QUALITY ASSURANCE -- NON-CONFORMANCE REPORT

Report No: NCR-000139

NCR #: ZPMC-0133

Reference Description: Base metal repairs

Welding	Concrete	Other	
Welding	Curing	Procedural	Bridge No: 34-0006
Joint fit-up	Coating	Other	Component: DP-051-001
Procedural	Procedural	Descriptor: OBG Deck Panel

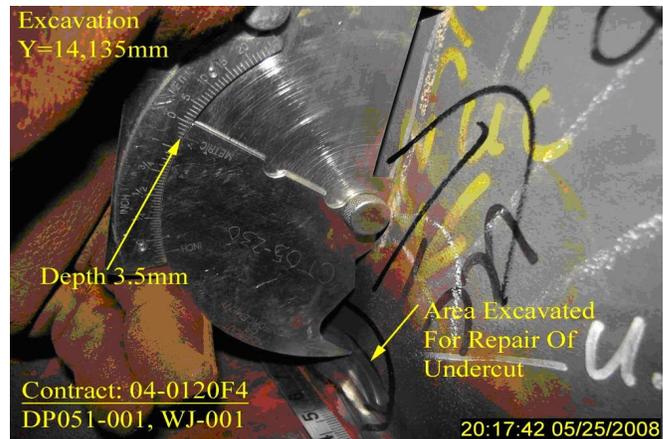
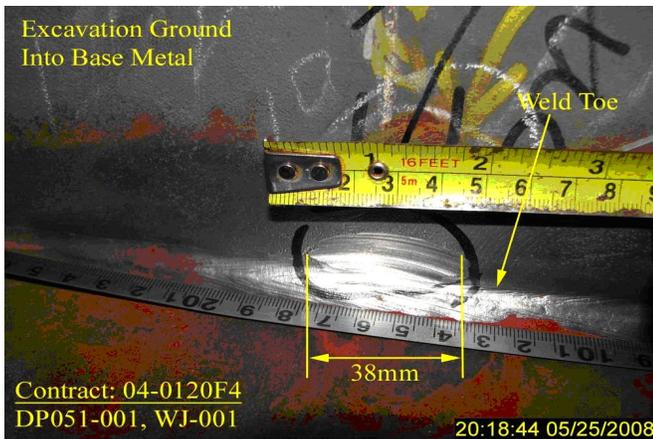
The Contractor performed base metal repairs without prior approval of the Engineer at weld joint #s -001, -002, -005, -006, -009 and -010 of deck panel DP-051-001. These six areas were ground for repair of undercut to a depth between 2mm and 3.5mm.

AWS D1.5, Section 3.7.4 "Prior approval of the Engineer shall be obtained for repairs to base metal....."

The response is not acceptable. The excavation of base metal was not described in the approved repair procedure. If the excavation of base metal is necessary for the repair of undercut, this to be incorporated into the repair procedure, and the maximum depth of the excavation of base metal is to be specified in the repair procedure.

The proposed resolution is acceptable. The repair procedure was submitted as part of ABF-SUB-634R06, and approved as noted. Also, the welds in question were accepted as shown on the attached VT, MT, and UT reports. The Department concurs that Non-Conformance ZPMC-0133 is closed.

Welding Concrete Other
 Welding Curing Procedural **Bridge No:** 34-0006
 Joint fit-up Coating Other **Component:** DP-051-001
 Procedural Procedural **Descriptor:** OBG Deck Panel

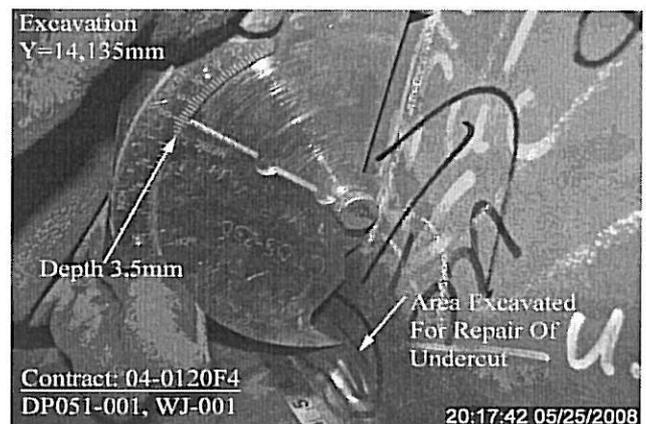
The Contractor performed base metal repairs without prior approval of the Engineer at weld joint #s -001, -002, -005, -006, -009 and -010 of deck panel DP-051-001. These six areas were ground for repair of undercut to a depth between 2mm and 3.5mm.

AWS D1.5, Section 3.7.4 "Prior approval of the Engineer shall be obtained for repairs to base metal....."

VT, MT, and UT reports for the welds in question were submitted by the Contractor showing the final examination of the weld. Also, the repair of undercut is addressed in the AAN submittal 634R06.

Although the Contractor's response does not address the systemic issue where the Contractor continues to perform repairs without notifying the Engineer, METS closed the NCR based on Team China Construction's direction.
